RE: DRAINAGE PLAN FOR PINNACLE VIEW ESTATES, TNIT II (J-23/D9C3) ENGINEER'S STAMP DATED NOVEMEER 12, 1992

RE: DRAINAGE PLAN FOR PINNACLE VIEW ESTATES, UNIT II (J-23/D9C3) ENGINEER'S STAMP DATED DECEMBER 20, 1991

DRAINAGE PLAN, CALCULATIONS, GRADING NOTES & SECTION PINNACLE VIEW ESTATES - UNIT I

TYPICAL TRICKLE CHANNEL SECTION SCALE: 1" = 1'0"

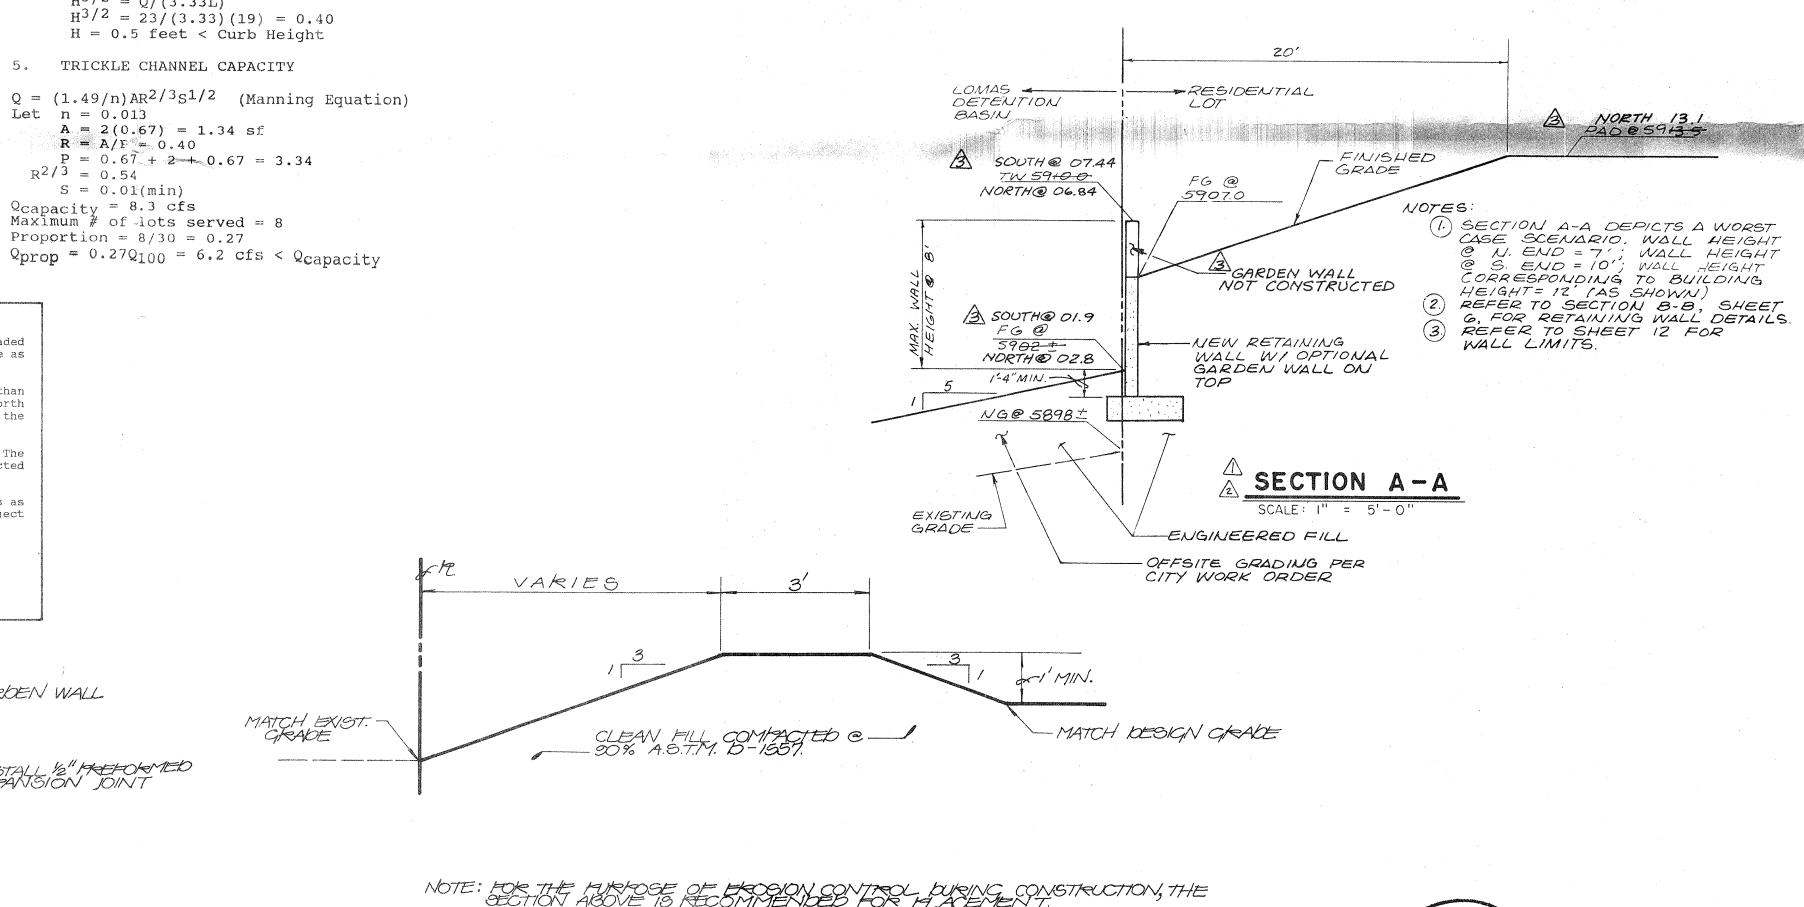
ENGINEER'S CERTIFICATION As indicated by the as-built information shown hereon, the proposed subdivision has been graded in substantial conformance with the approved Grading and Drainage Plan. Noted deviations are as The private trickle channel bordering Lots 15 and 16 was constructed at lower elevations than designed so as not to interfere with the existing block wall which lies along the north boundary of the lots. This has increased the slope of the trickle channel, hence the capacity of this drainage facility has not been diminished.
